Memorandum

Subject: Implementing Assembly Bill 1531 (DeSaulnier)

ACCESSIBLE PARKING OFF-STREET

STATE OF CALIFORNIA
DEPARTMENT OF TRANSPORTATION
ACCESSIBLE PARKING
ON-STREET

REVISED STANDARD PLAN RSP A90A

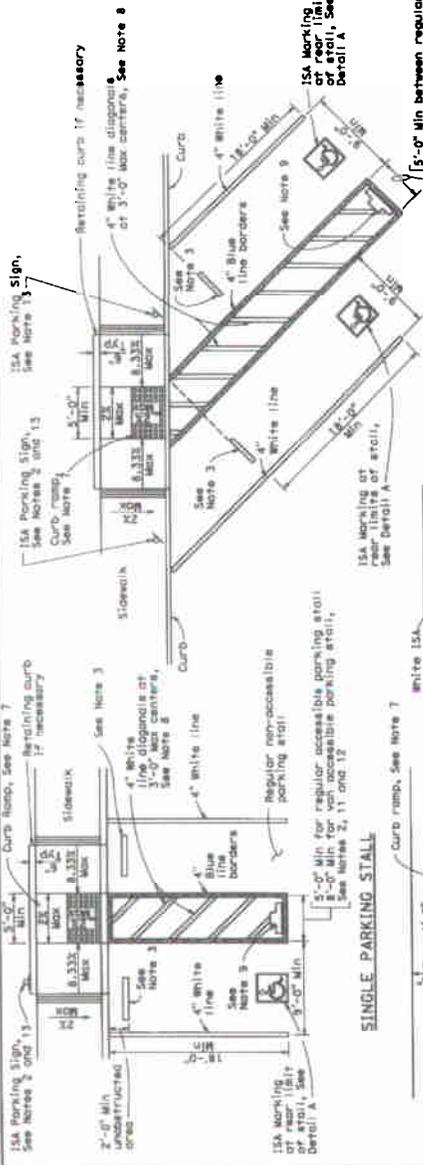
Effective July 1, 2008 Assembly Bill (AB) 1531 (DeSaulnier) requires changes to the standards for signing and marking of accessible parking. These changes have been incorporated in the attached revised standard plans (RSPs) A90A - Accessible Parking Off-Street, and A90B - Accessible Parking On-Street. All parking facilities that are under the jurisdiction or control of the California Department of Transportation are subject to the requirements of AB 1531.

The following changes to off-street and on-street accessible parking signs and markings were made:

1. Accessible Parking Only (R99 (CA)) with Minimum Fine \$250 plaque below (R99B (CA)), or
2. Accessible Parking Minimum Fine \$250 sign (R99C (CA)), and
3. Disabled Tow-Away sign (R100B (CA)), and
4. Blue border striping of the loading and unloading access aisle.
